**VIVOD ESTATE**

**APPLICATION FOR A TECHNICAL VARIATION OF EXISTING IMPOUNDMENT LICENCE  
(WA/067/0005/005)**

Off-take Channel entrances (Photo 2)

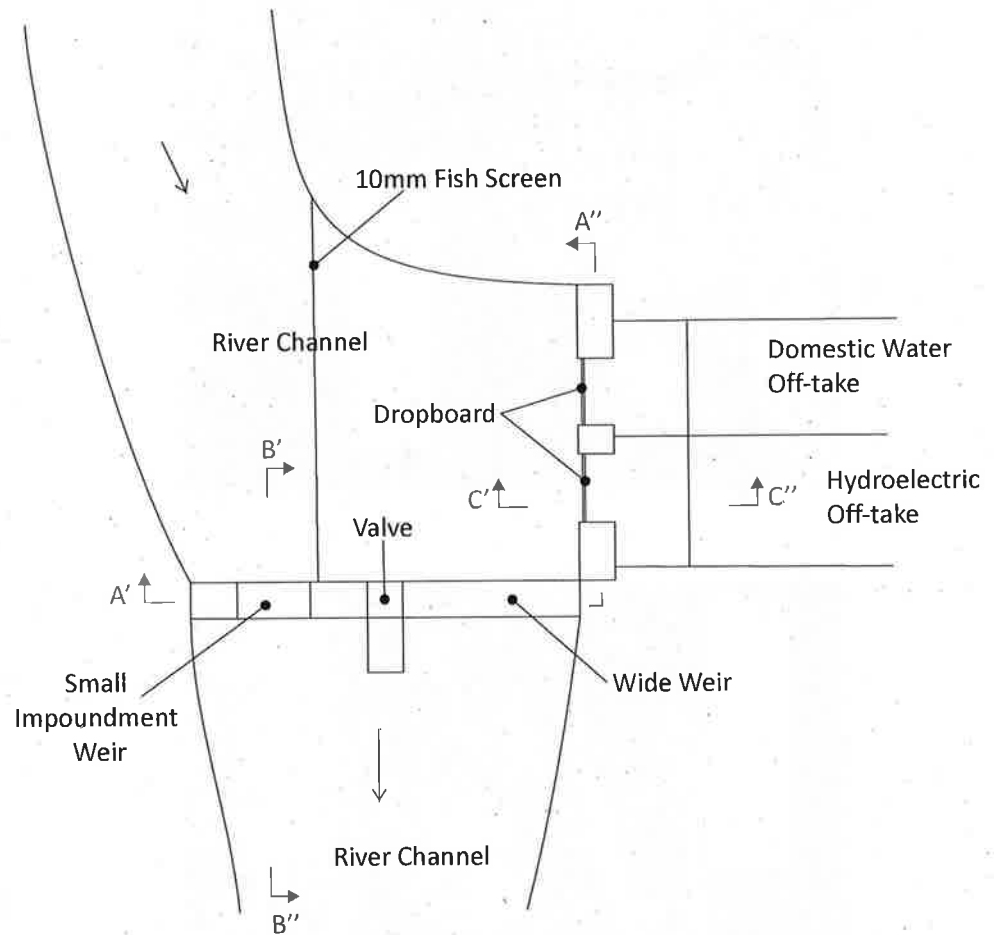
The Off-take Channel has two entrances, each with drop down boards that can restrict flows (see Figure 2, Photo 2). These drop boards are currently set at 5cm above the invert of the Off-Take Channel entrances, the entrances are currently 2cm below the invert level of the small impoundment weir. Currently flows within the channel are controlled by a valve. NRW have specified that they do not want the flows in the watercourse controlled by a valve on a permanent basis, therefore although the impoundment structure has been in operation since 1922 an alternative method of control is required. Based on Envireau Water's assessment, this can be achieved with modifications to the existing impoundment structure. This will be different to the arrangement detailed in the impoundment licence.

Plan

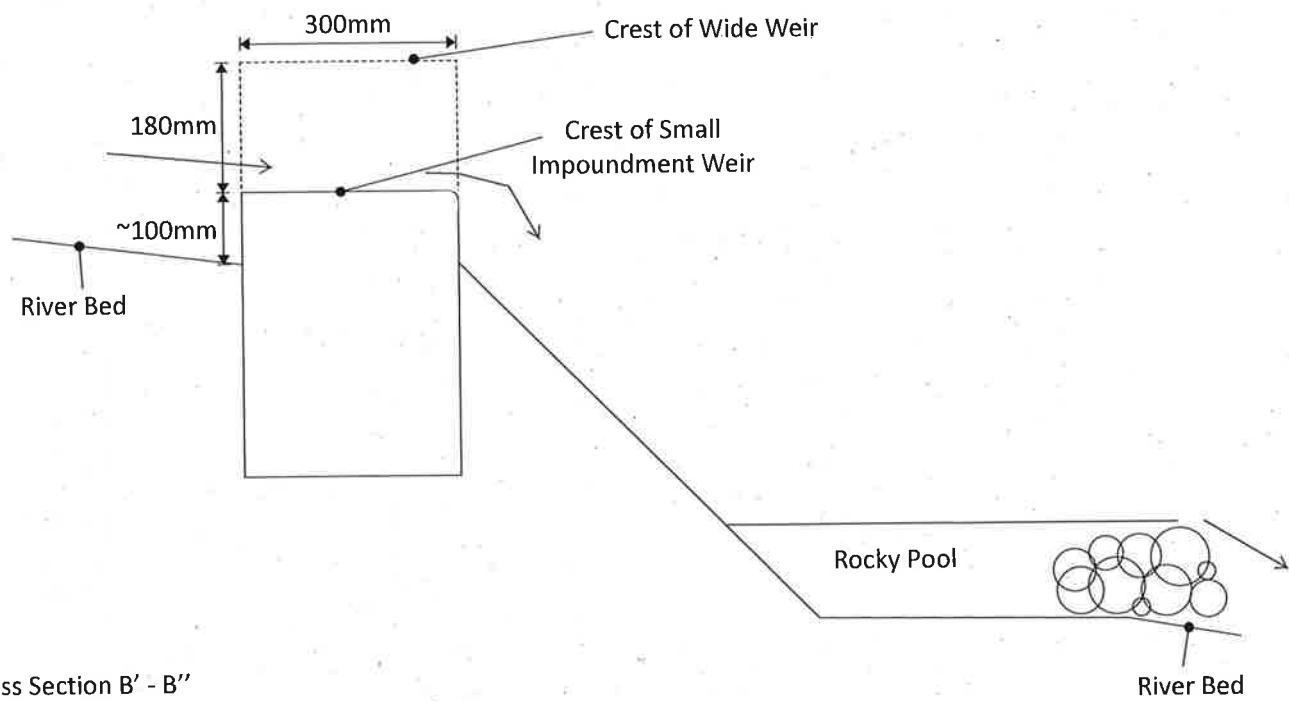
The proposed impoundment structure utilises the existing structure by raising the invert of the Hydroelectric Power Off-take Channel to 3.5cm above the inverts of the small impoundment weir and domestic water supply offtake. The invert for the domestic water supply is to be set at the same level as the small impoundment weir.

A schematic plan of the proposed structure is provided in Figure 3 with a cross section of the wide weir, small impoundment weir and Off-takes provided in Figures 4 and 5. A 2mm wire 10mm aperture vertical fish screen will be installed in front of the Off-take Channel drop boards.

A rocky pool will be created below the impoundment structure as shown on Figure 3 to provide a refuge for fish at the impoundment.

Cross Section B' - B''  
Scale 1:10 at A4

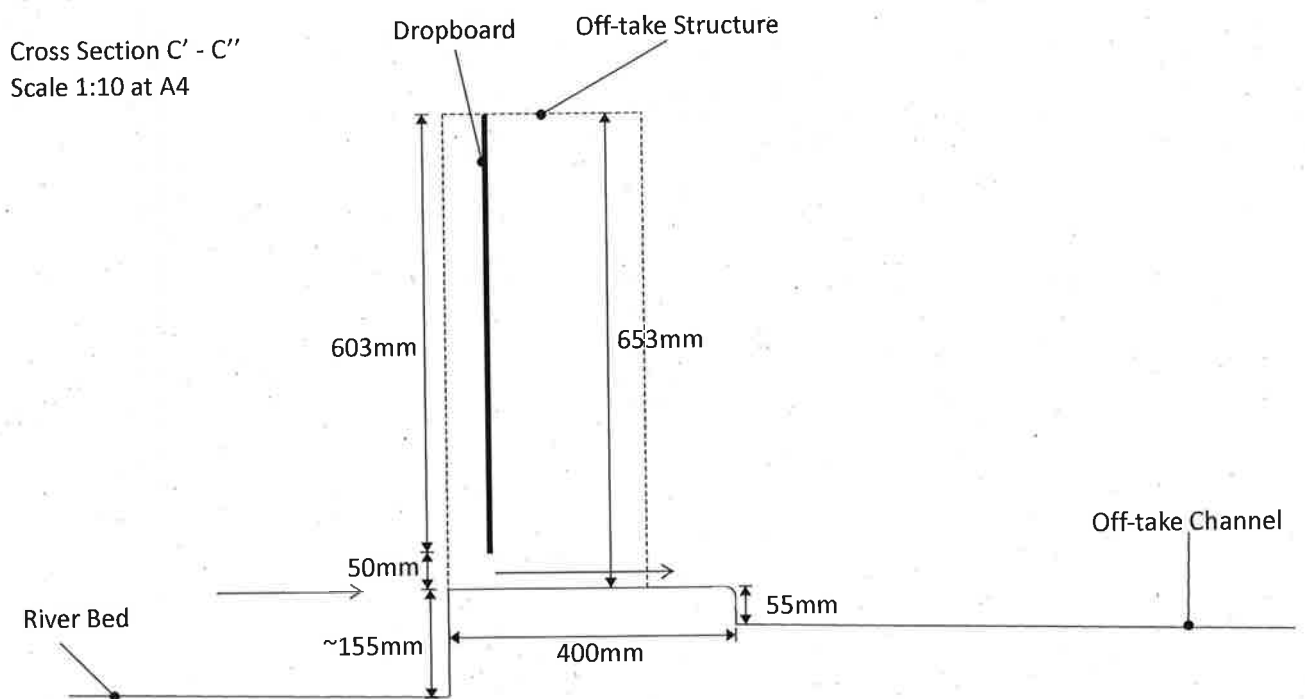
- The domestic supply offtake has the same invert level as the small impoundment weir. When flows are equal to or less than 9.6 l/s (i.e. equal to or less than 3.5cm water depth at the small impoundment weir), the drop board is set to a gap of 18mm to restrict flows at the domestic offtake to a maximum of 1.8 l/s.

- The HEP offtake invert is set 3.5cm above the invert of the small impoundment weir so that abstraction for the HEP can only occur when flows are above the 7 l/s HOF condition.

## Existing Arrangement with Valve

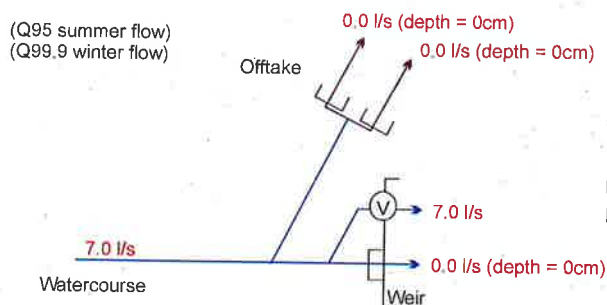
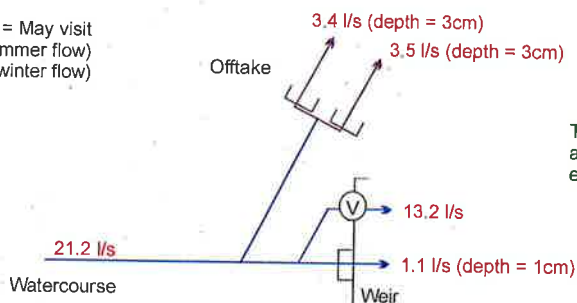
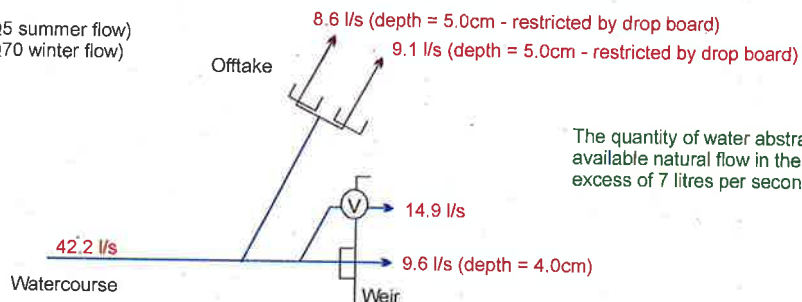
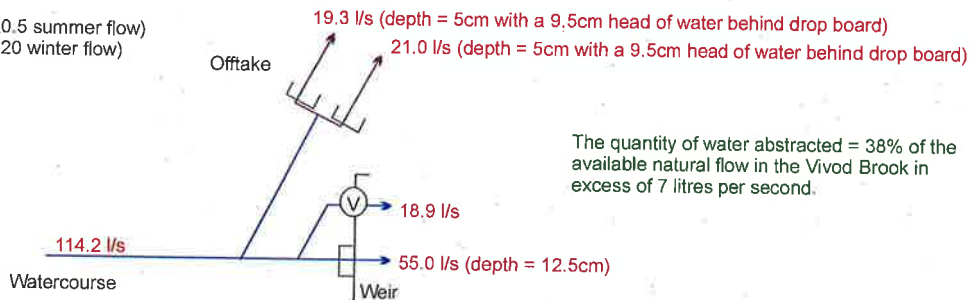
The current arrangement is presented in the form of a line diagram on Figure 4. Figure 4 shows that increasing the flows to circa. 42 l/s and 114 l/s changes the quantity of water abstracted in excess of 7 l/s to 50% and 38%, respectively. This shows that the existing arrangement is currently compliant for the existing abstraction licences.

- Watercourse small weir invert set ~ 2cm higher than 1st and 2nd Off-take Channel entrance inverts

= No domestic abstraction achieved  
Natural flow in watercourse maintained.

Manual adjustment of valve required to provide up to 1.8 l/s for the domestic supply
